Rebuttal Report of Christian R. Petrich

In the Matter of Application for Transfer No. 73811 (Shekinah Industries); Application for Transfer No. 73834 (Orchard Ranch); Application for Permit No. 63-32499 (Mayfield Townsite); Application for Permit No. 61-12095 (Nevid-Corder); Application for Permit No. 61-12096 (Nevid); Application for Permit No. 63-32703 (Orchard Ranch); Application for Permit No. 61-12256 (Intermountain Sewer & Water); Application for Permit No. 63-33344 (ARK Properties-Mayfield Townsite) before the Idaho Department of Water Resources

January 30, 2013

Figure 1. Inferred groundwater flow directions at study-area boundaries.

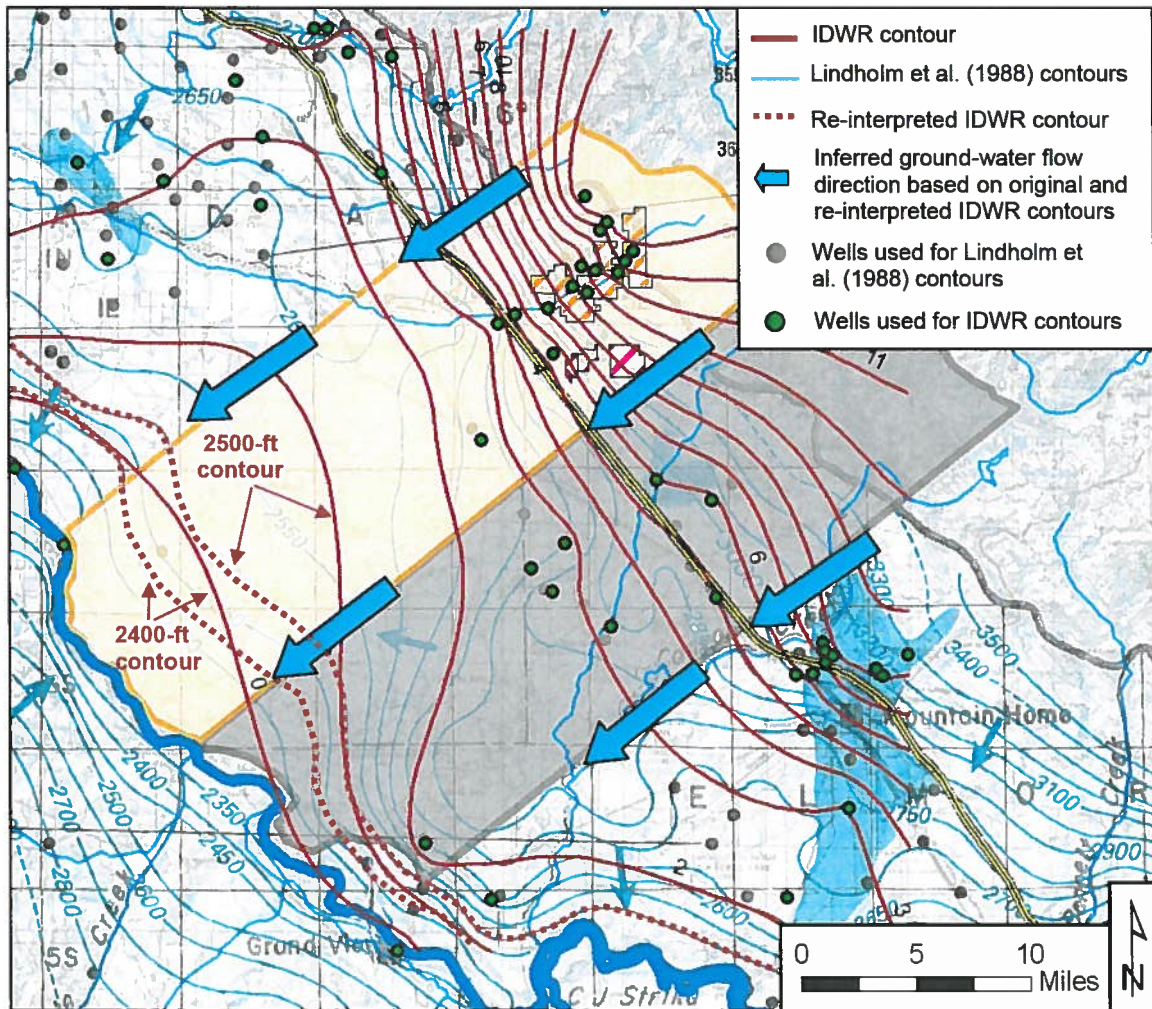
The up-gradient boundary was defined as a surface-water flow divide (e.g., the ridge separating the Snake River and South Fork Boise River drainages). Similarly, the down-gradient boundary was established at the Snake River, which clearly is a groundwater-flow divide based on regional groundwater-level contours (Lindholm et al., 1988). There does not appear to be any disagreement regarding the use of these up-gradient and down-gradient boundaries.

The southwest-northeast study-area boundaries are based on groundwater flow lines. Groundwater flow lines can be used to represent no-flow hydraulic boundaries (Anderson and Woessner, 1992), as long as cones of depression from the proposed pumping do not substantially impact groundwater levels at the boundary. In this case, there is no evidence that existing pumping inside or outside of the study area has materially impacted groundwater levels within the study area.

That said, the southwest-northeast study-area boundaries are not entirely perpendicular to IDWR’s groundwater-level contours (see Figure 4 of the IDWR Staff Memo) in the southern portion of the study area. As such, the study boundaries appear to not be aligned along regional flow lines in this area. However, Lindholm et al. (1988) defined regional groundwater-level contours using a much larger (and more regional) data set. Figure 1 shows (a) Lindholm et al.’s groundwater-level contours, (b) IDWR groundwater-level contours presented in Figure 4 of the IDWR Staff Memo, and (c) IDWR water-level contours that SPF reinterpreted based on the previous Lindholm et al. contours. Inferred groundwater flow lines based on the IDWR contours and Lindholm et al. regional groundwater-level contours represent a reasonable basis for IDWR’s southwest-northeast study-area boundaries.

Figure 2. Surficial geology in the vicinity of the upper Blacks Creek drainage.

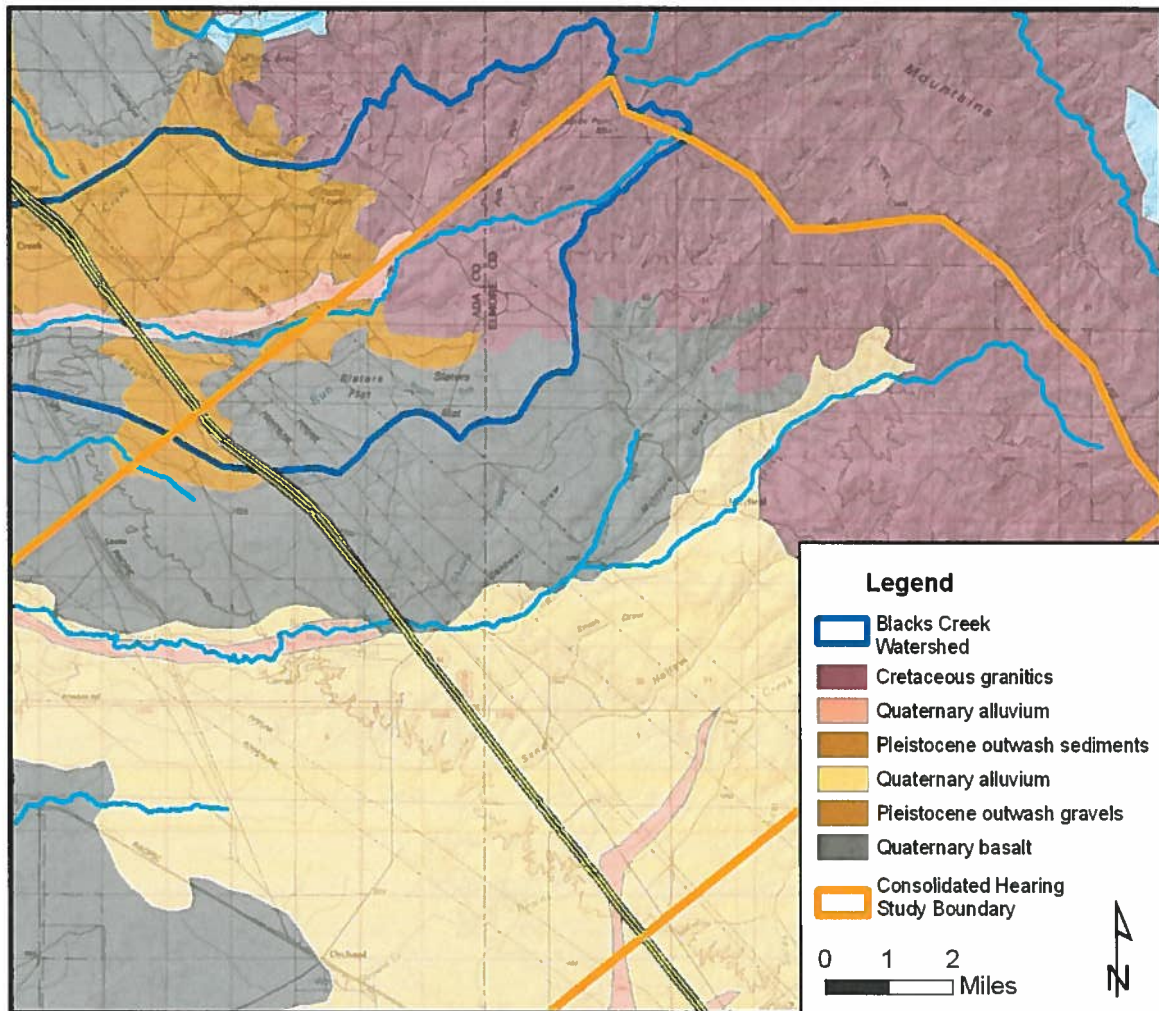
Memo). Alluvial sediments at the granitic bedrock contact (Figure 2) provide a pathway for downward groundwater movement along flow lines in Figure 4 of the IDWR Staff Memo toward deeper sedimentary zones. Similarly, infiltration into granitic joints and fractures in upper portions of the Blacks Creek drainage also likely migrates basinward within study boundaries, as illustrated in Figure 18 of the Welhan report (Welhan, 2012).

Figure 3. Locations of wells in the upper Blacks Creek drainage with groundwater-level data.

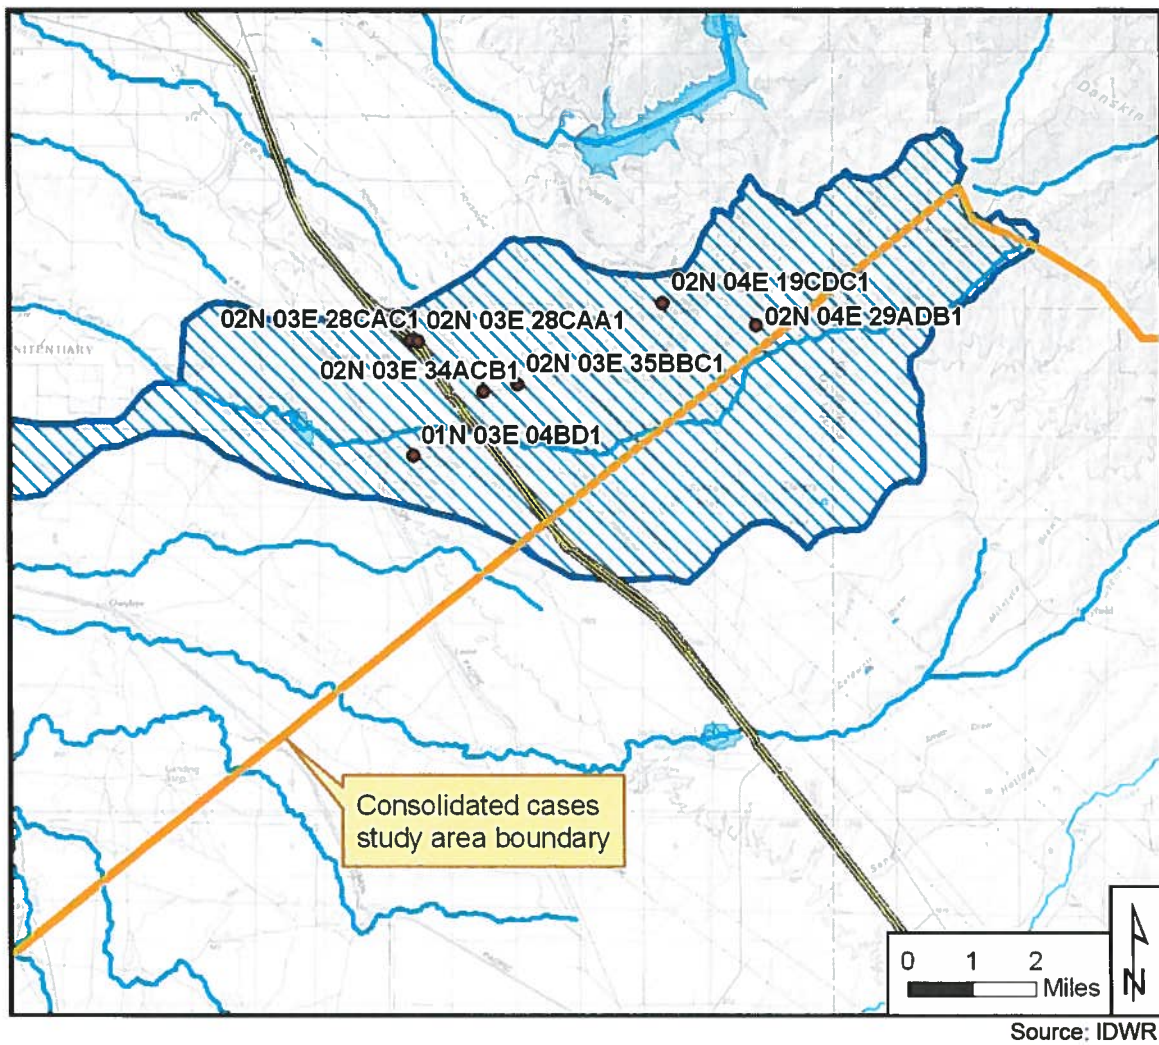
Locations of wells in the upper Blacks Creek drainage with publicly-available groundwater-level data are shown in Figure 3. Hydrographs from these wells (Figure 4 and Figure 5), including a well within ¼-mile from the point of diversion for water right 63-11540, show no groundwater-level declines, indicating that diversions authorized under water right 63-11540 have not created (and therefore likely will not create) groundwater-level declines in the upper Blacks Creek drainage area. Thus, it appears that ERO's concerns about long-term effects of pumping outside this portion of the study area are unfounded.

Figure 6. Average annual precipitation (in inches) in the consolidated cases "non-recharge" area.

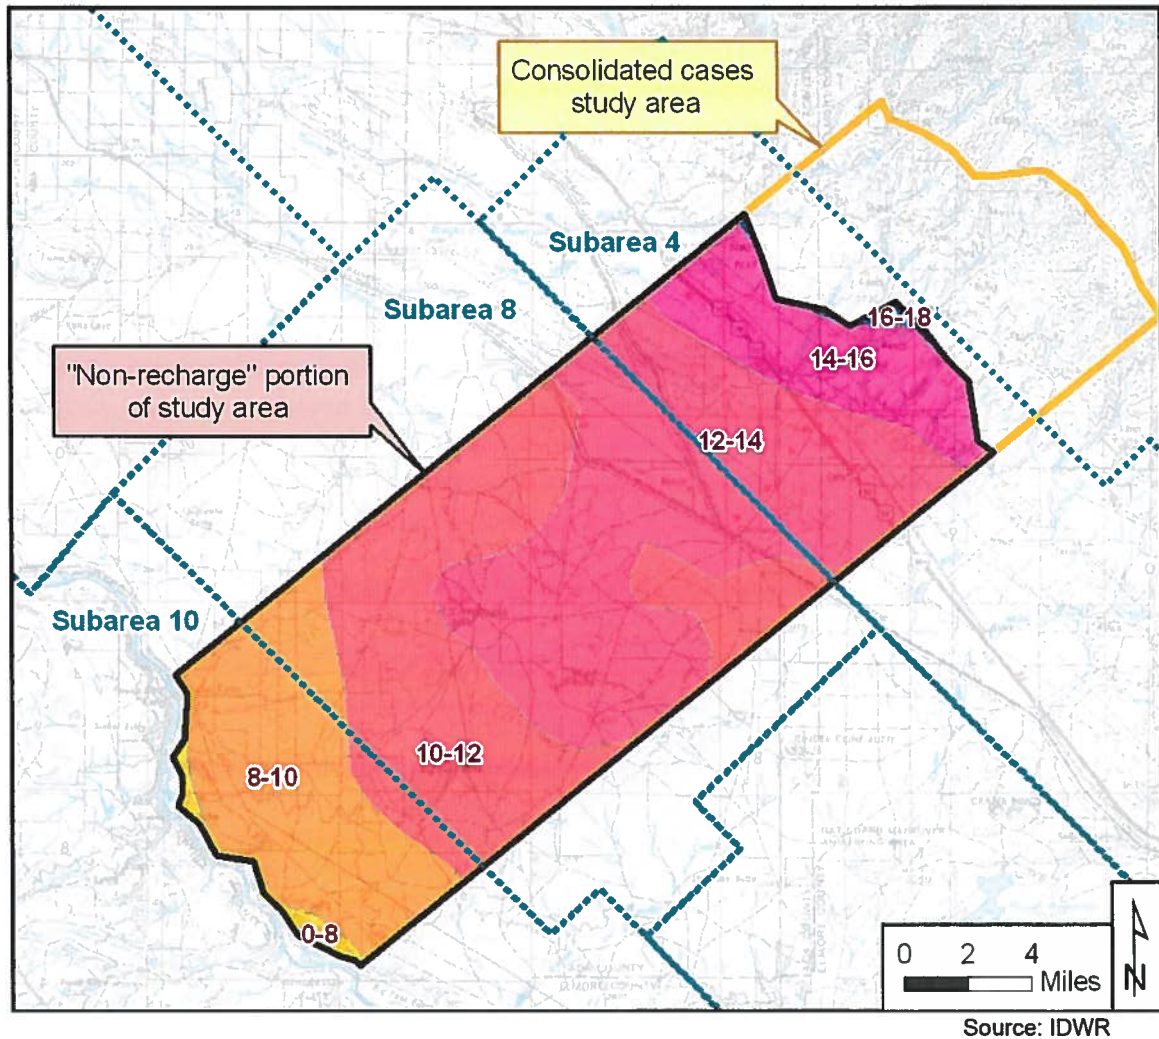
The “non-recharge” portion⁷ of the consolidated cases study area ranges in elevation from approximately 2,300 feet (at the Snake River, or approximately 2,800 feet at the canyon rim above the Snake River) to 3,600 feet⁸. Low-elevation portions of the “non-recharge” area receiving an average of 8 to 10 inches (or less) of annual precipitation (Figure 6) represent a relatively small portion of the “non-recharge” area. However, higher-elevation portions of the “non-recharge” area receive 14-16 inches of precipitation per year (or more).

Figure 7. Townships in the consolidated cases study area and adjacent comparison area.

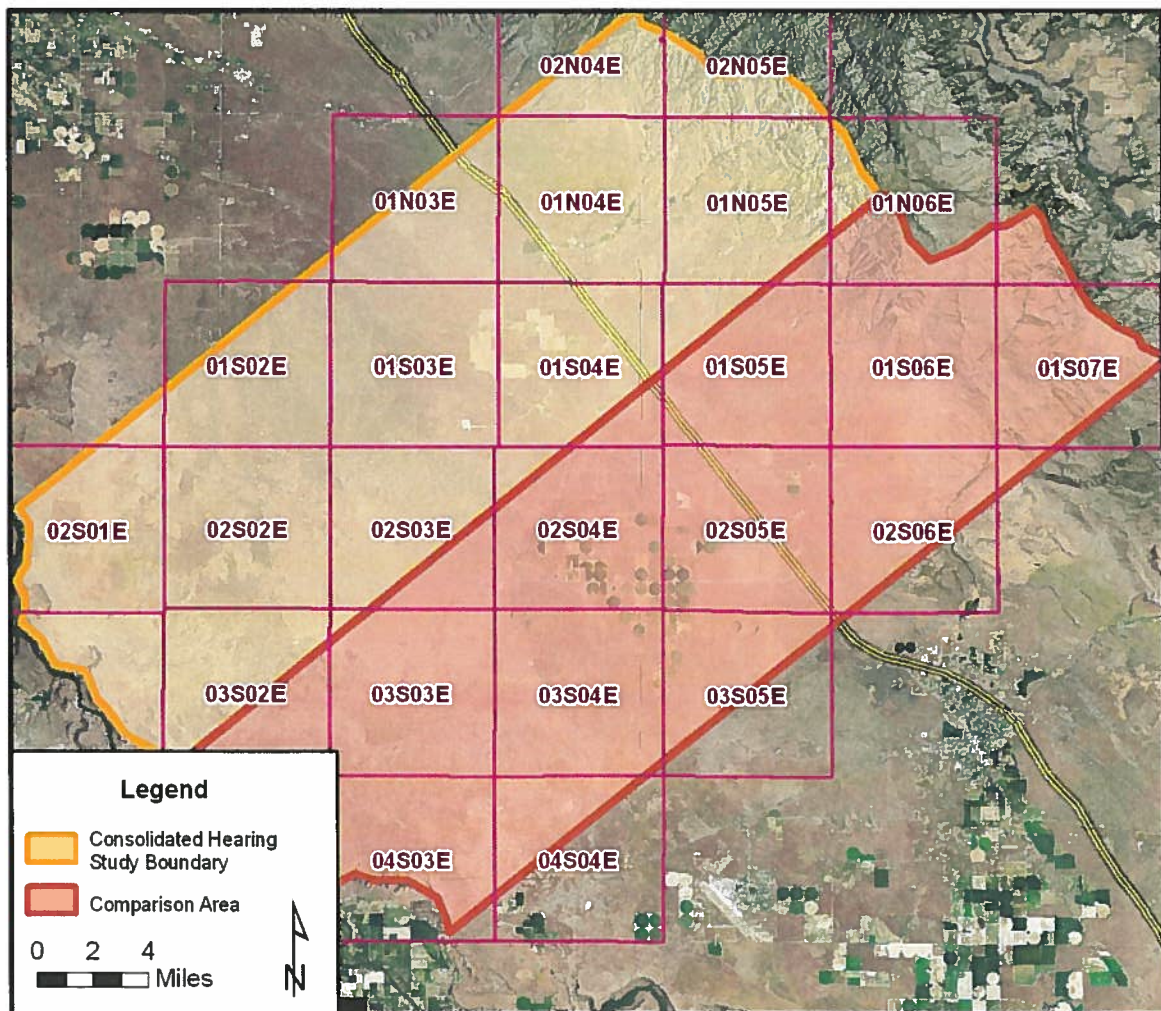
Response, Part 2: ERO suggests that “impermeable zones above the regional water table described in drillers’ reports for wells constructed in Townships 2 and 3 South and Ranges 4 and 5 East prevent precipitation from reaching the regional water table” (ERO Report, page 16), and argues that this is another reason that recharge from precipitation in the “non-recharge” area should not

be included in the water budget. However, the wells to which ERO refers are in the Cinder Cone Butte comparison area, not the study area (see Figure 7). Lithologic descriptions from these Cinder Cone Butte CGWA wells do not adequately describe stratigraphy in the consolidated cases study area.

Figure 8. Portion of "non-recharge area" from which recharge capture is likely.

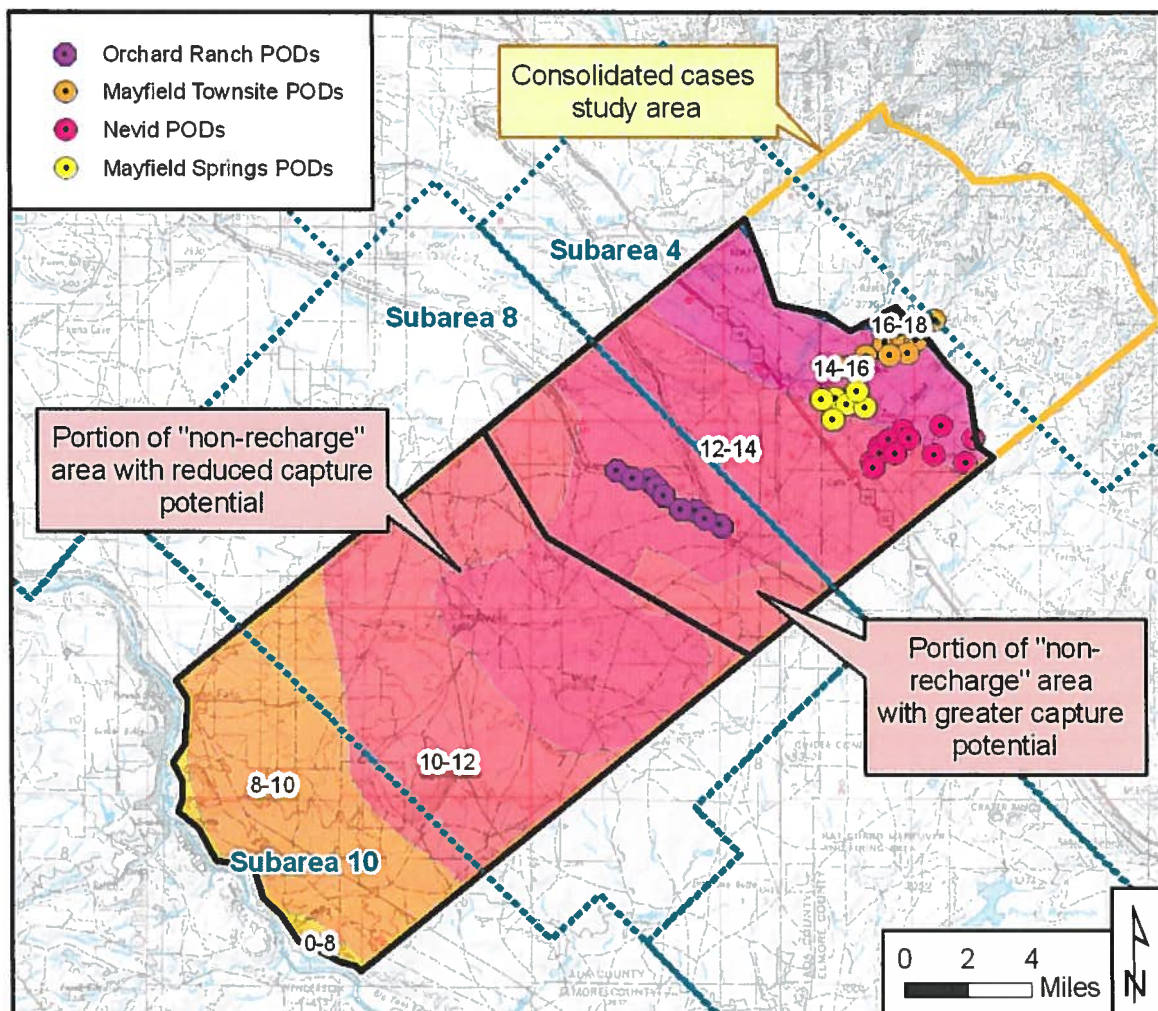
Figure 8 illustrates a portion of the “non-recharge” area with greater potential of capturing recharge originating from the “non-recharge” area and an area with reduced capture potential. The line separating these two portions of the “non-recharge” area is approximately 3 miles down-gradient of the Orchard Ranch wells, which presumably could develop an approximate 3-mile capture radius.

The amount of average annual recharge generated within the portion of the “non-recharge” area having greater capture potential was estimated using the same estimated USGS recharge percentages (Newton, 1991) and PRISM data that IDWR used in developing a recharge estimate for the “non-recharge” area. Using this approach, the amount of recharge within the portion of the “non-recharge” area having greater capture potential is approximately 1,950 acre-feet per year (Table 1).

Figure 9. Comparison of Newton (1991) model zone locations interpreted by IDWR and SPF.

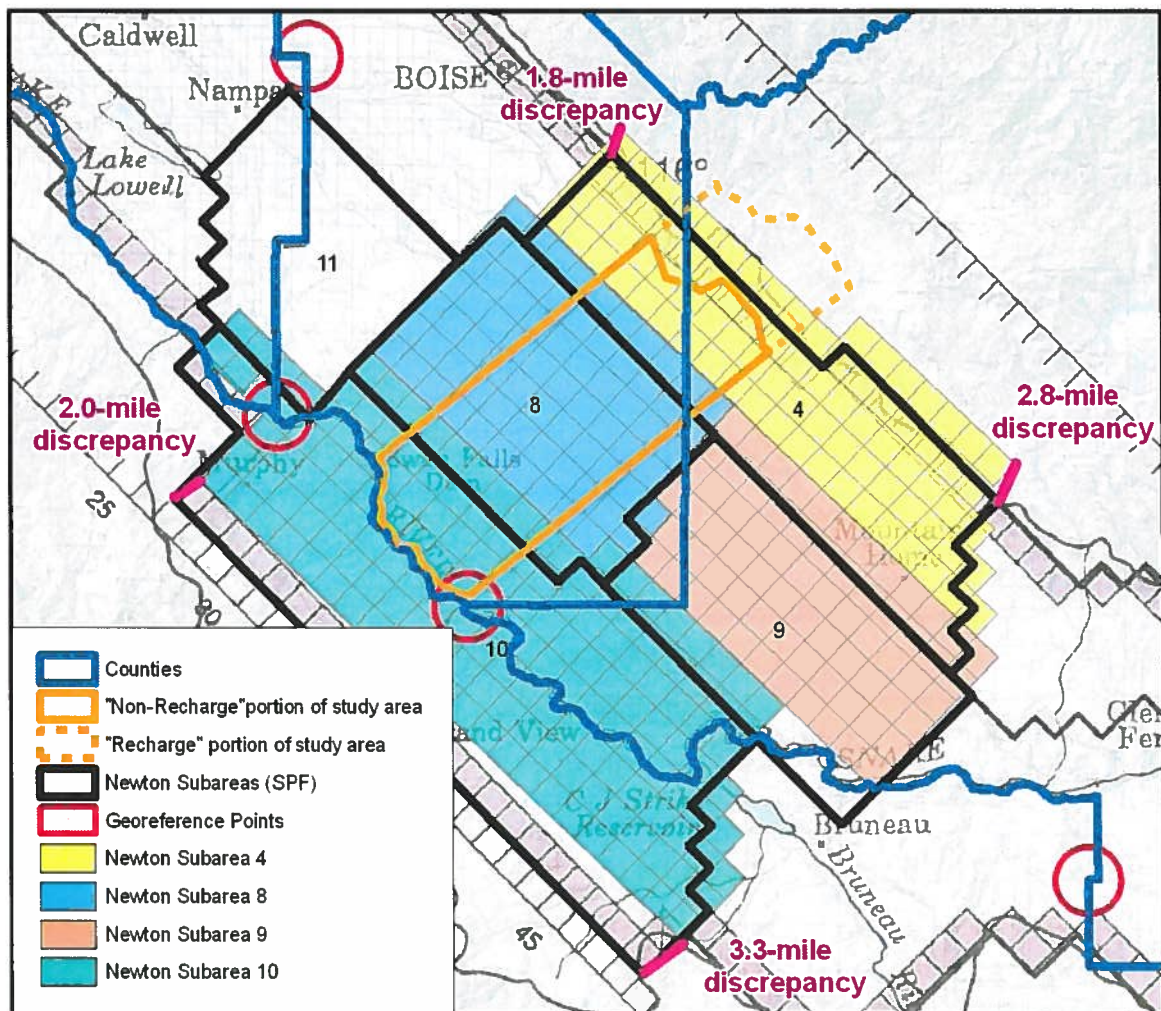
The geo-referencing discrepancy is illustrated in Figure 9. SPF scanned Figure 17 in the Newton (1991) report and geo-referenced this map using county shapefile polylines (6 points) as reference points. IDWR's geo-referencing was off by distances

of 1.8 to 3.3 miles at four representative corner points (Figure 9). Examples of SPF's geo-referencing points are shown in Figure 10. The net result is that there is a larger portion of USGS subarea 4 and a smaller portion of Subarea 10 in the consolidated cases study area than calculated by IDWR.

Figure 11. Trust area and places-of-use for consolidated applications.

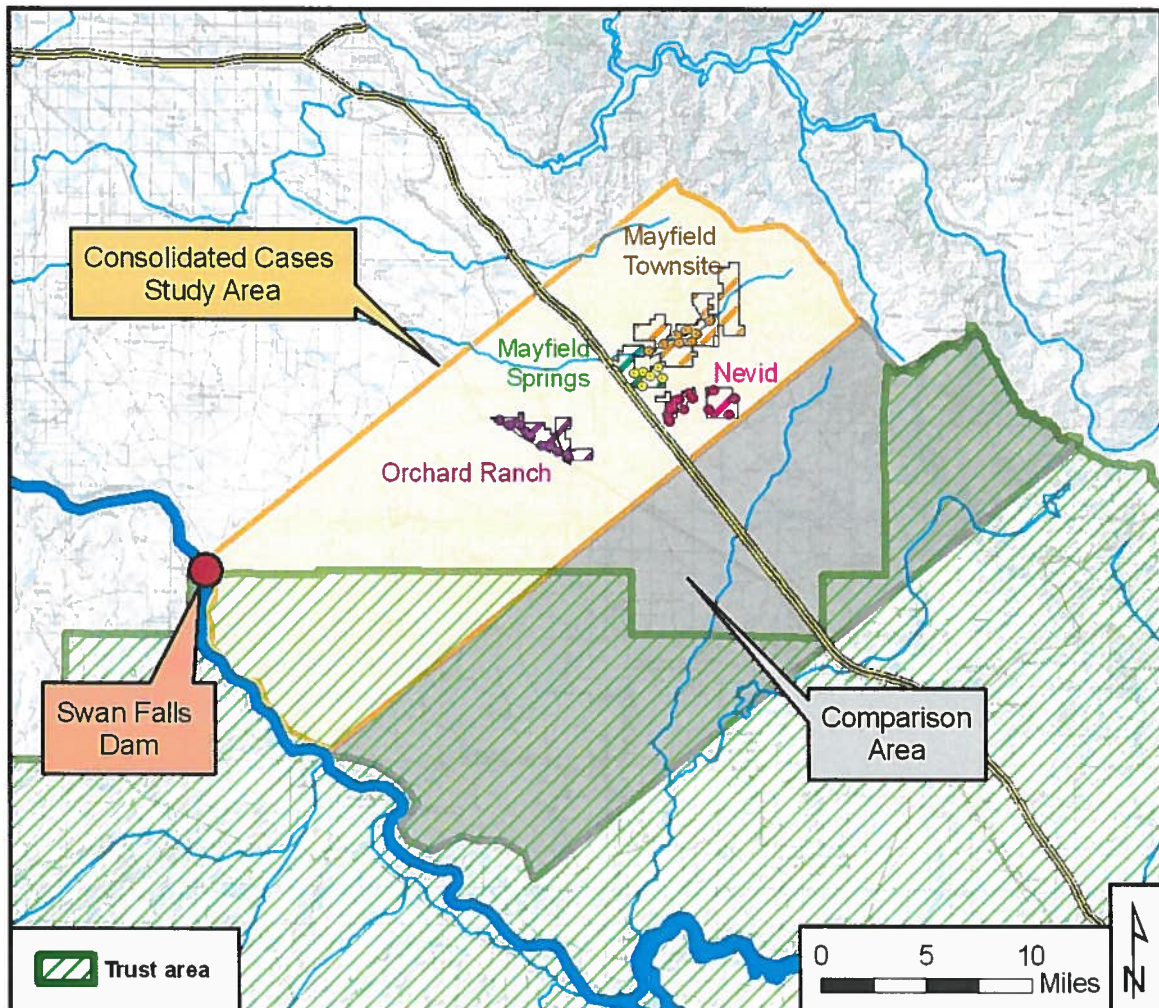
Points of diversion and places of use for the two referenced permits (63-32225 and 61-12090) are not within the trust area boundary defined under IDAPA 37.003.008 (Figure 11). These applications were not protested based on concerns regarding trust water impacts. Consideration of trust water impacts was therefore not required for the processing of these permits. Furthermore, points of diversion and or places of use for applications that are part of this consolidated administrative process (Applications 63-32499, 61-12095, 61-12096, 63-32703, 61-12256, and 63-33344) also lie outside of the trust area (Figure 11).
